Access Compliance Report

Public Rights-of-Way

(Curb Ramps)

Intersection ID: 31215	Main Street: OLDEHURST_PL	Cross Street: WRAYHILL_DR	Location: SW
ADA ID: F924F256B381	Ramp Type: PerpDiag	Initial Pass/Fail: Fail	Overall Compliance: No
Severity Score: 33.75			
Codes/Mitigation Info/Possible Solution		Field Measurements/Component Compliance

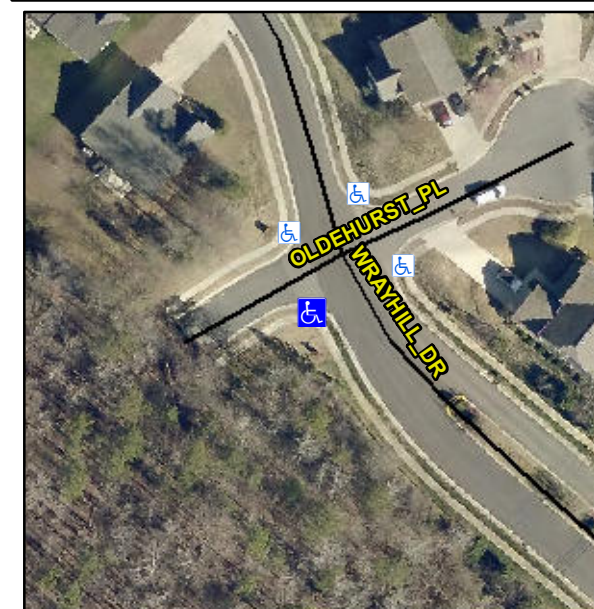
Not Found, R304.5.1, R304.2.2

Compliance	Description	Data	Compliance	Description	Data
N/A	Ramp Length (in)	52.0	No	Ramp Slope (%)	12.0
No	Ramp Width (in)	42.0	Yes	Ramp XSlope (%)	0.7
N/A	Flare Type LT	N/A	N/A	Flare Type RT	N/A
N/A	Flare Slope LT (%)	N/A	N/A	Flare Slope RT (%)	N/A
N/A	Flare Traversable LT?	N/A	N/A	Flare Traversable RT?	N/A
N/A	Landing Length (in)	N/A	N/A	DWS Provided?	N/A
N/A	Landing Width (in)	N/A	N/A	DWS Contrast?	N/A
N/A	Landing Slope (%)	N/A	N/A	DWS Length (in)	N/A
N/A	Landing X Slope (%)	N/A	N/A	DWS Full Width?	N/A
N/A	Landing Curb? (Y/N)	N/A	N/A	DWS Offset (in)	N/A
N/A	Shared Landing?	N/A			
N/A	Gutter Ponding?	N/A	N/A	Gutter Slope (%)	N/A
N/A	Gutter Lip Ht (in)	N/A	N/A	Gutter X Slope (%)	N/A
N/A	Painted X Walk1?	No	N/A	Painted X Walk2?	No
	X Walk 1 Direction	To E		X Walk 2 Direction	To N
N/A	X Walk 1 Width (in)	N/A	N/A	X Walk 2 Width (in)	N/A
	X Walk 1 Slope (%)	1.3		X Walk 2 Slope (%)	0.6
	X Walk 1 X Slope (%)	0.9		X Walk 2 X Slope (%)	1.2

Remove & Replace Curb Ramp With Two New Directional Ramps or Equivalent.
